BEN LOMAND MOUNTIAN VILLAGE

EL PASO COUNTY, CO

PRELIM PLANS - NOT FOR CONSTRUCTION

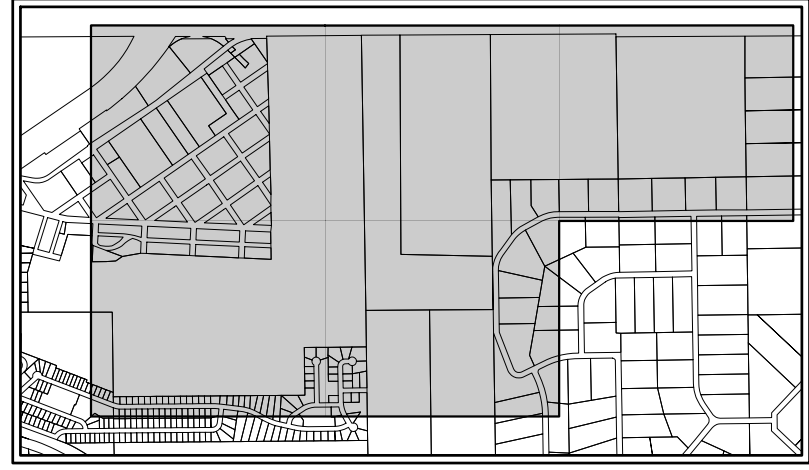
This applies to all wetlands not just federal. Please place in No-build areas and depict on lots in Preliminary Plan. The Wetlands report identifies many wetlands. Please coordinate with USACE on qualifying wetlands

HYBRID LOCAL ROADWAY
ROW (60')
N.T.S.

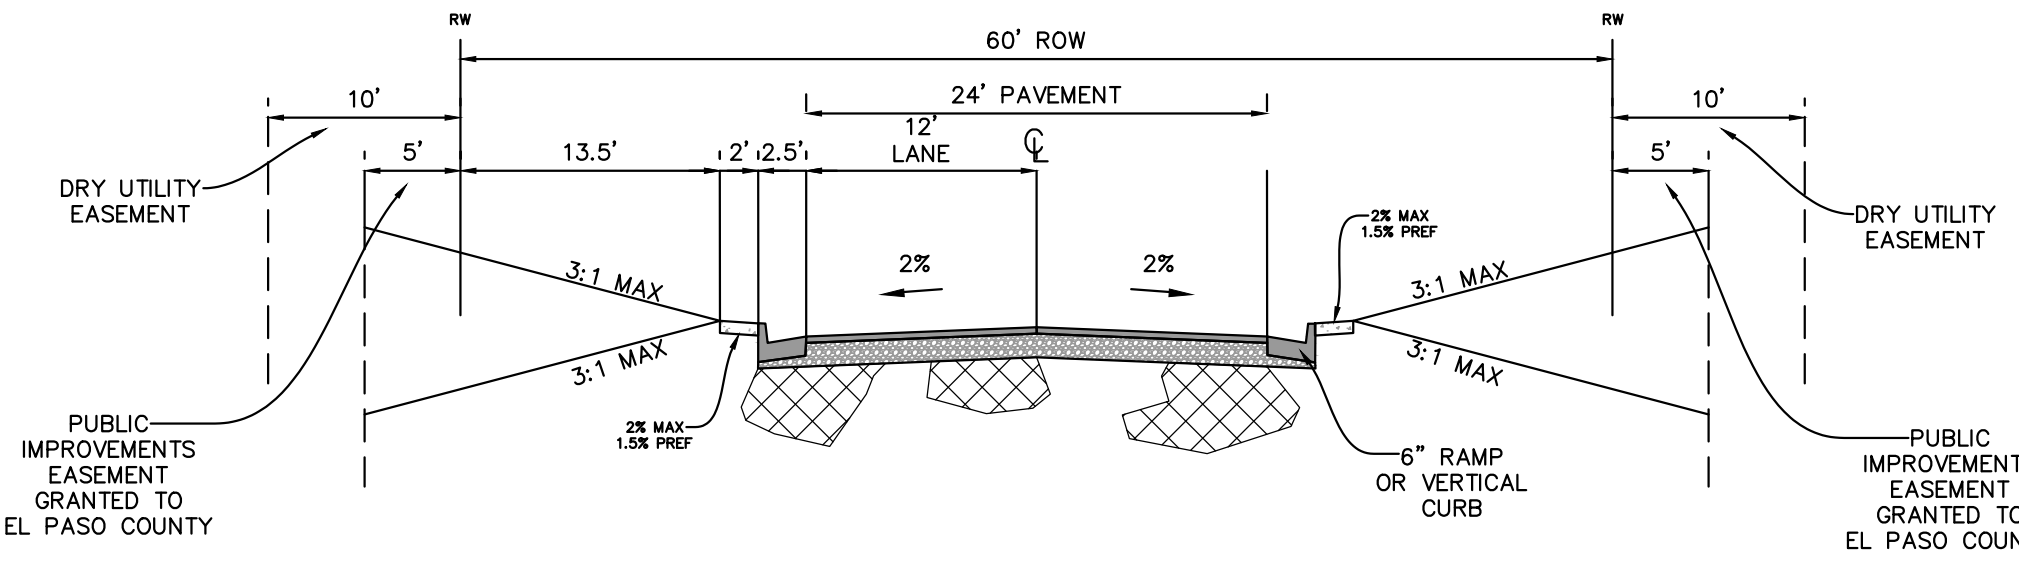
Use EPC ECM standards in Chapter 2

PRELIMINARY PLAT

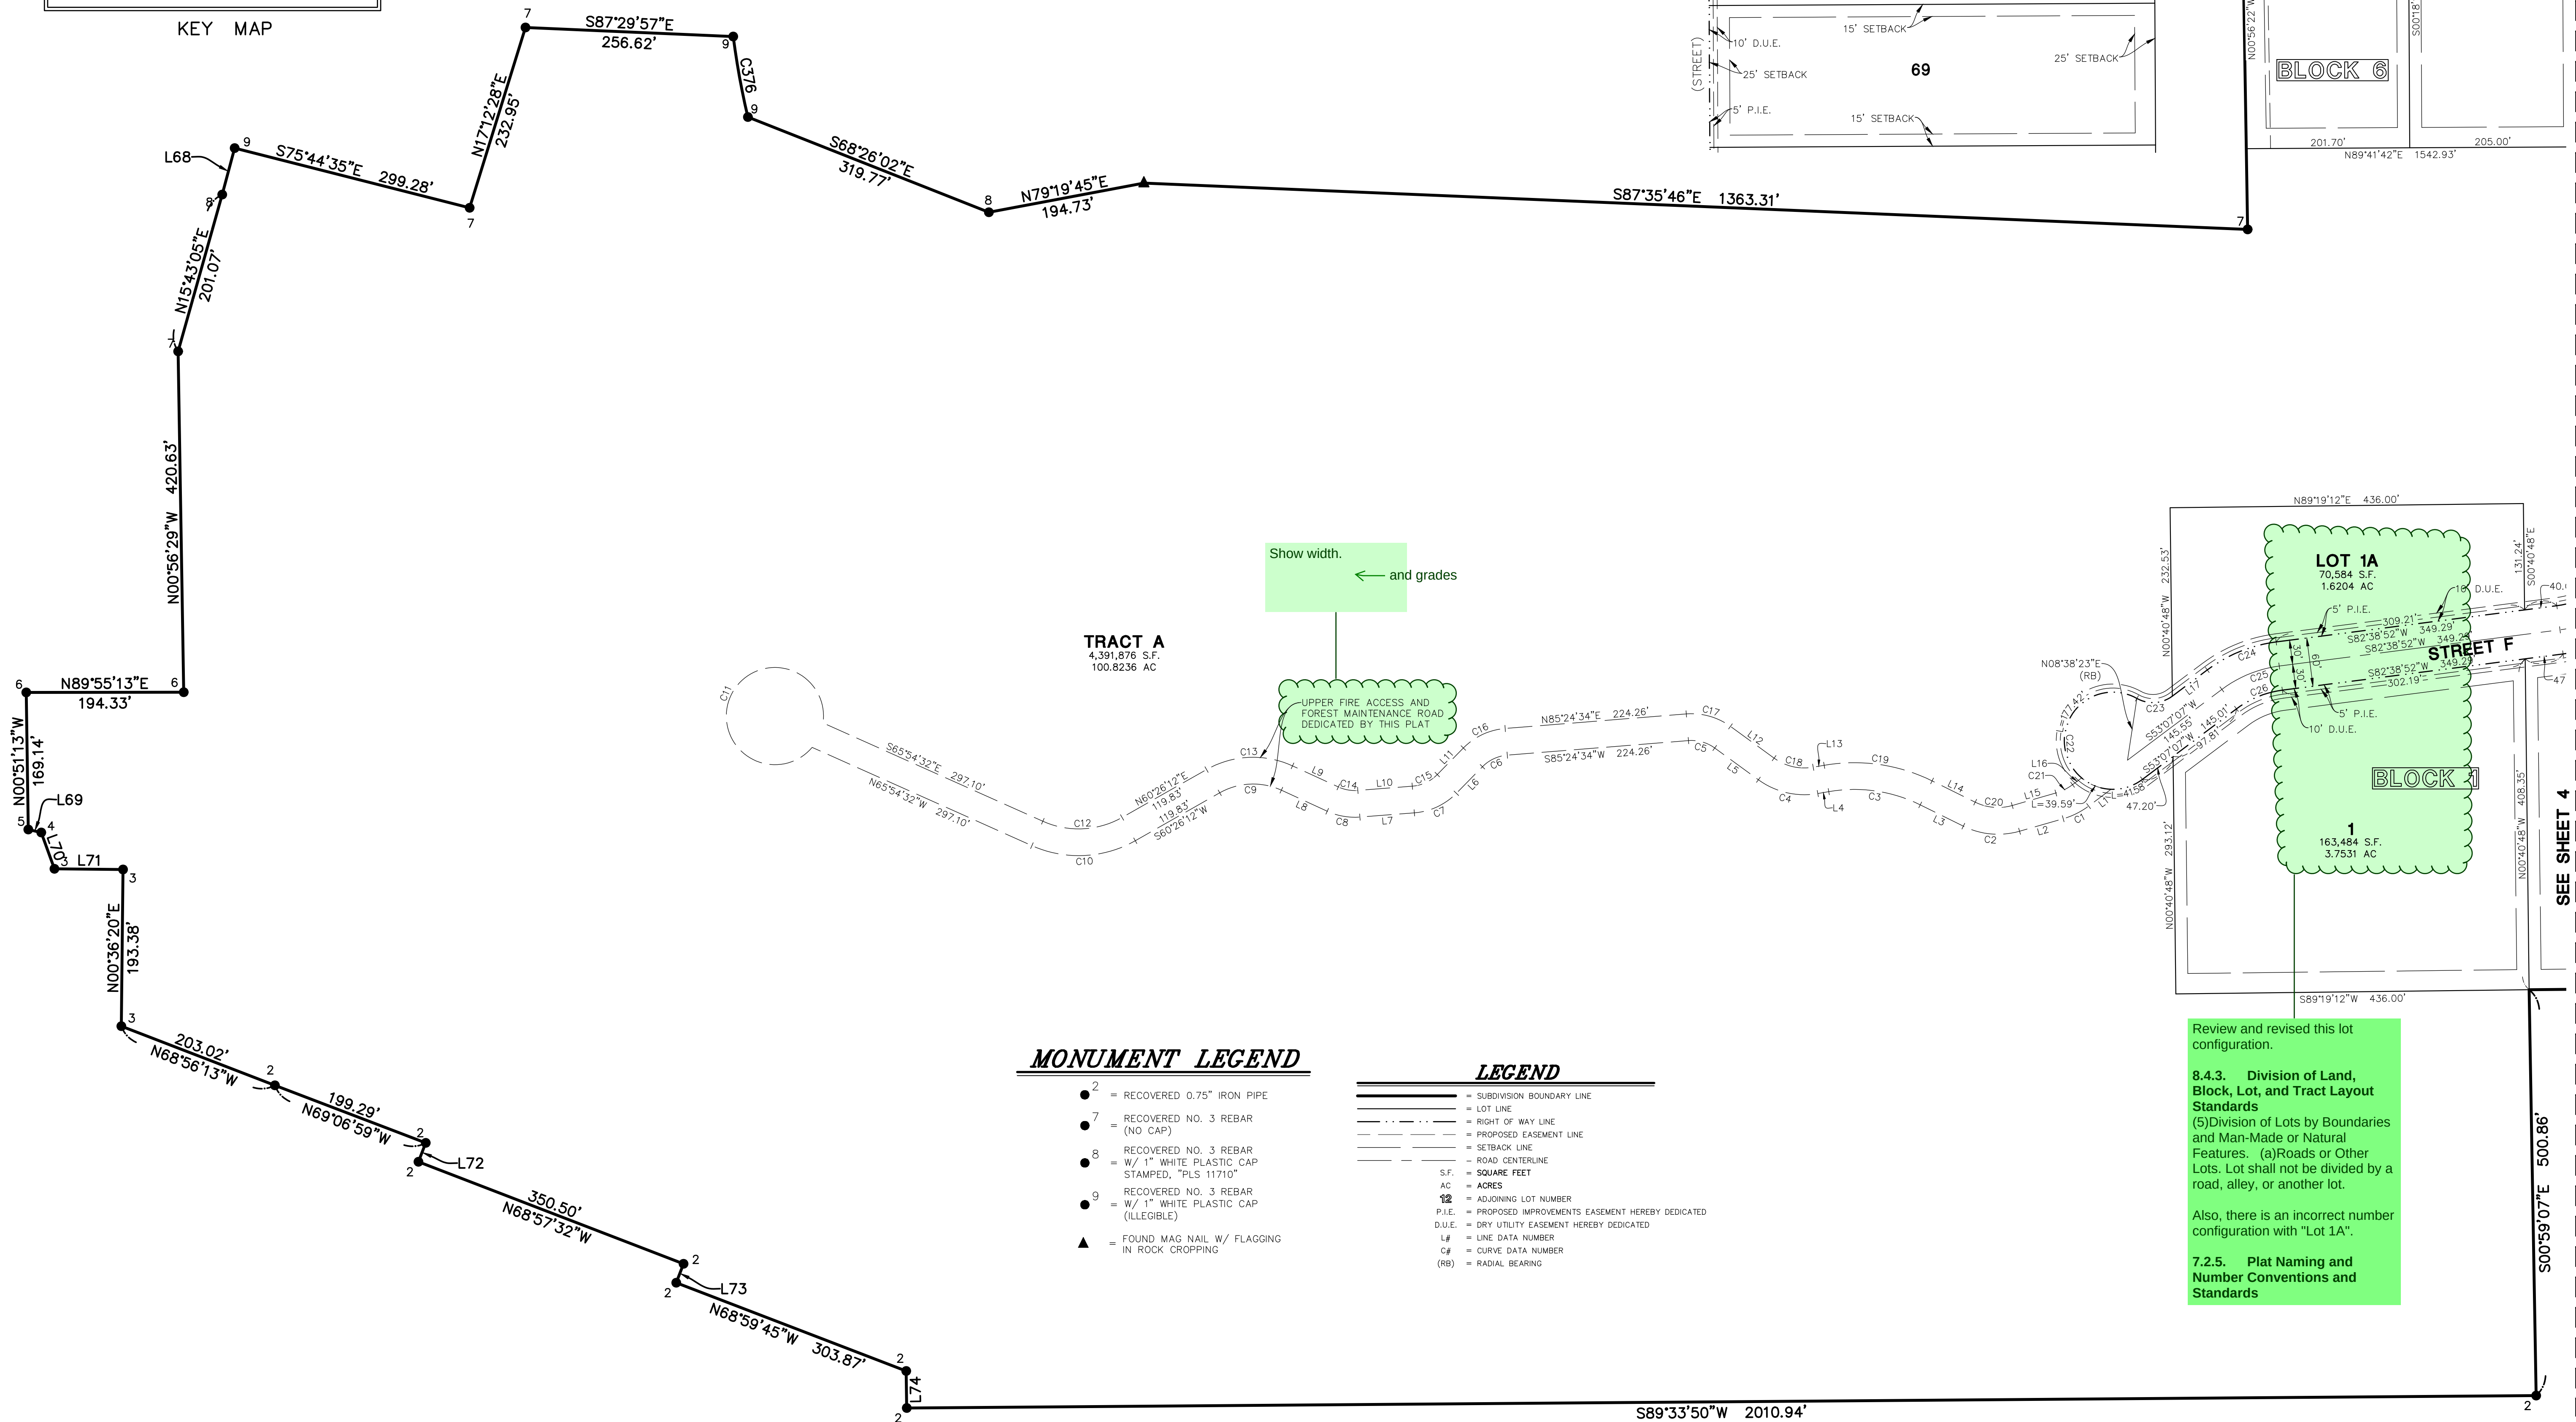
Please add a specific easement note regarding which lots have landscape easements.

Review and revised this lot configuration.

8.4.3. Division of Land, Block, Lot, and Tract Layout Standards
(5) Division of Lots by Boundaries and Man-Made or Natural Features. (a) Roads or Other Lots. Lot shall not be divided by a road, alley, or another lot.

Also, there is an incorrect number configuration with "Lot 1A".

7.2.5. Plat Naming and Number Conventions and Standards

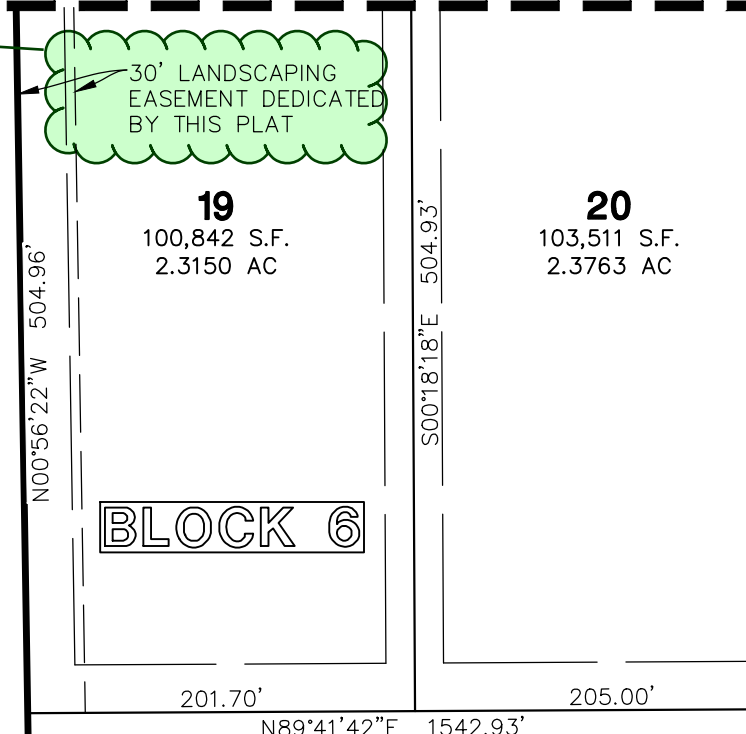
Show width. ← and grades

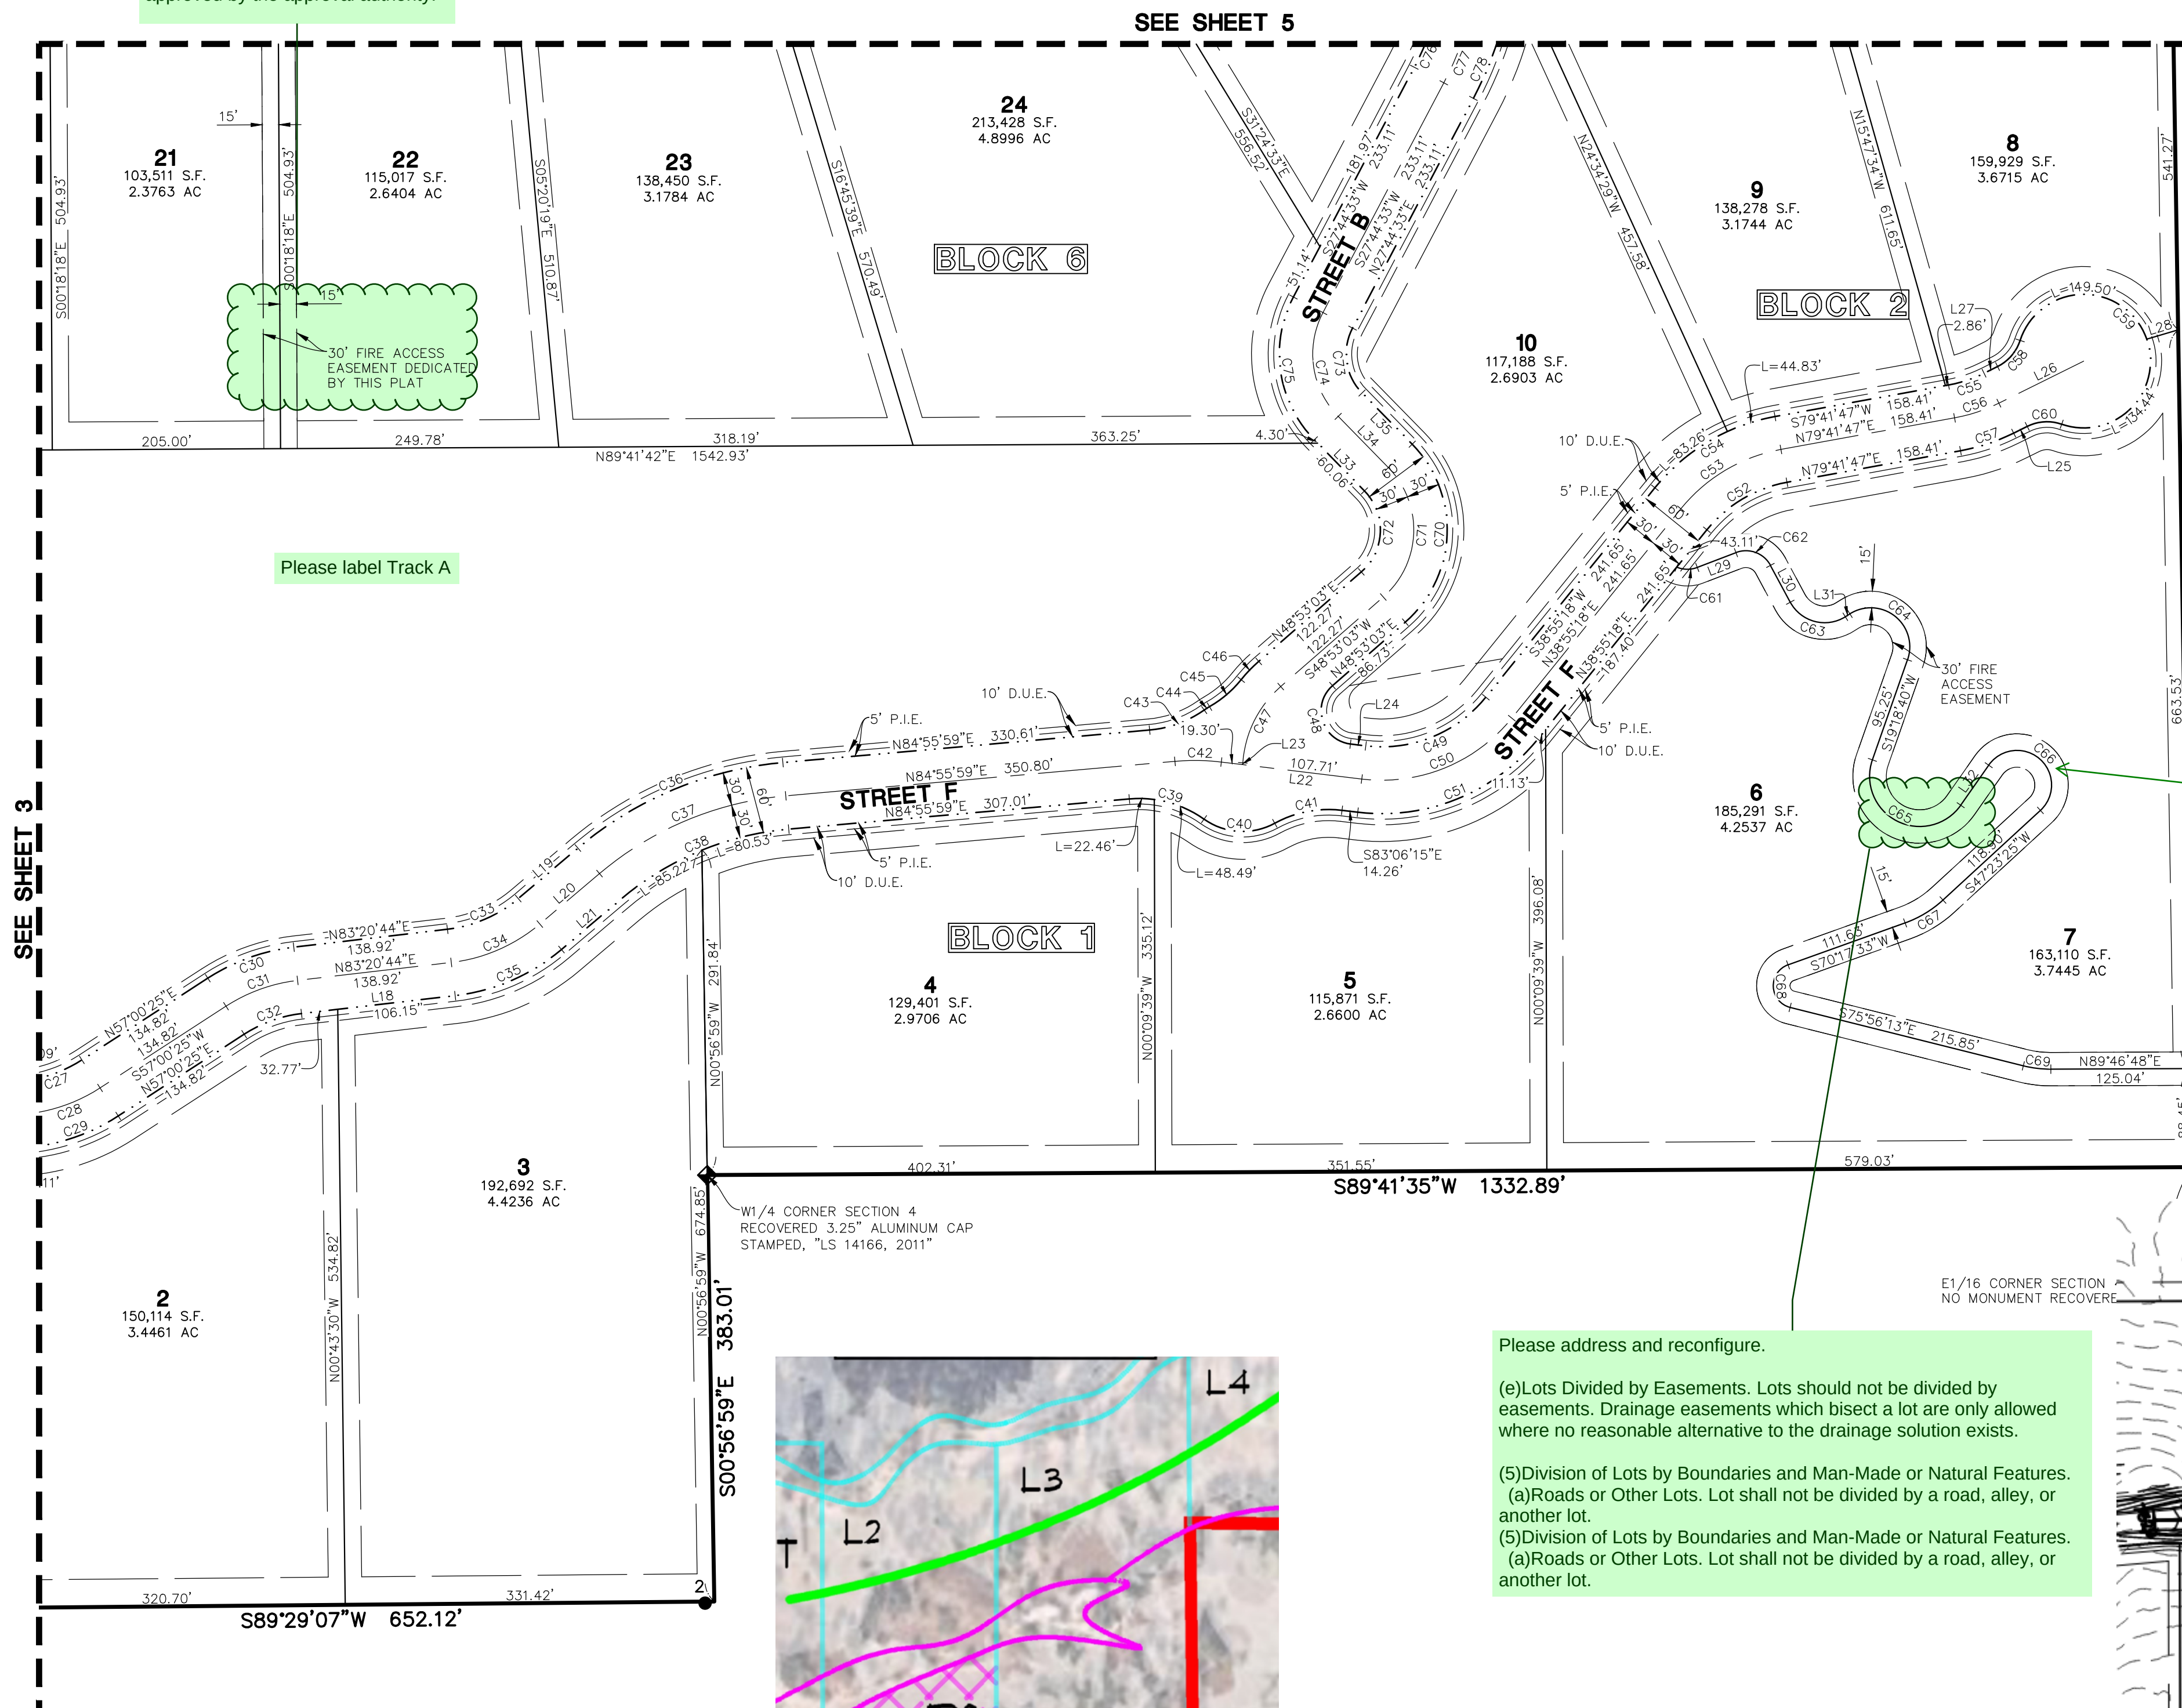
Please show • Cistern Turnaround: A dedicated turnaround shall be placed no more than 50 feet from a fire cistern, and the standpipe shall be within 8 feet of the nearest usable portion of the dedicated right-of-way or approved easement, unless otherwise recommended by the applicable Fire Authority and approved by the approval authority.

turning radius,
surface and weight
shall be provided in a
detail

Please add more detail to explain line work, no-building, steep slope, hatching etc.
